REMARKS/ARGUMENTS

Application No. 10/799,780  
Reply to Office Action of November 10, 2005

**REFERENCE FIG. 1**

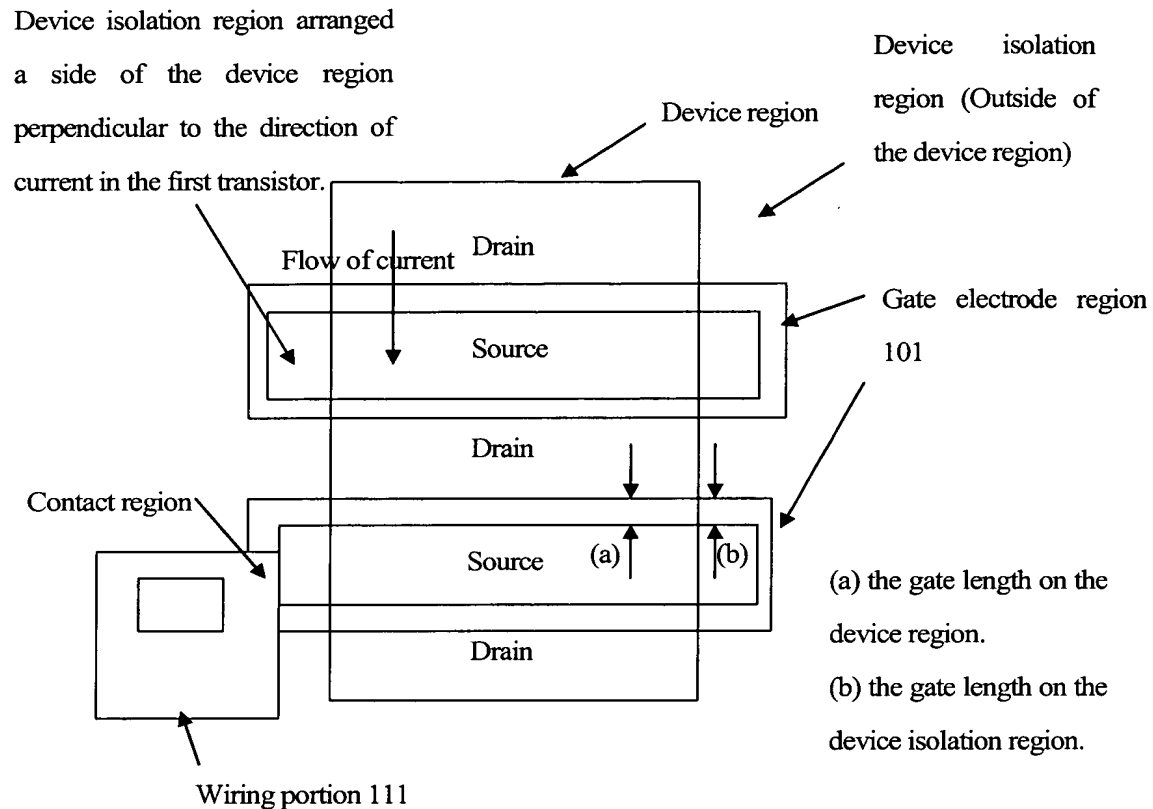
Applicants respectfully traverse the objection to the drawings as not showing the subject matter of Claim 8. Claim 8 recites,

8. The semiconductor device of claim 1, wherein respective loop-shaped gate electrode regions have same lengths on the device region and a device isolation region except contact regions between wiring portions and the gate electrode regions.

Thus, in Claim 8, the loop-shaped gate electrode region has same length on the device region and the device isolation region. As shown in Reference Figure 1 presented on the next page of this paper, (a) is the gate length on the device region and (b) is the gate length on the device isolation region. The “exception” in Claim 8 regarding the contact regions between the wiring portions and the gate electrode regions arises because the length of the contact portion connected to the wire portion of the loop-shaped gate electrode is sometimes lengthened for secure connection to the wire portion, as shown in the left bottom portion of the Reference Figure 1. This structure further distinguishes over the Kumagai reference, which in Fig. 4A shows a gate 108a which has shorter channel region (right side) than others. Nevertheless, it is respectfully submitted that the subject matter of Claim 8 is shown in Figure 1 of the present application, and withdrawal of the objection to Claim 8 is respectfully requested.

have the same length and/or with respect to what exception. In response, Claim 8 has been amended to delete reference to “the” in referring to “respective loop shaped gate electrode regions.” Further, as explained above in regard to the above Reference Figure 1, in this figure, (a) is the gate length on the device region and (b) is the gate length on the device isolation region, as is believed apparent to persons skilled in the art from Figure 1 of Applicants’ disclosure. Accordingly, the rejection of Claim 8 under of 35 USC §112, 2<sup>nd</sup> para., is believed to have been overcome. If the Examiner disagrees, the Examiner is requested to clarify the basis of the rejection and/or make suggestions as to how this ground for rejection can be overcome.
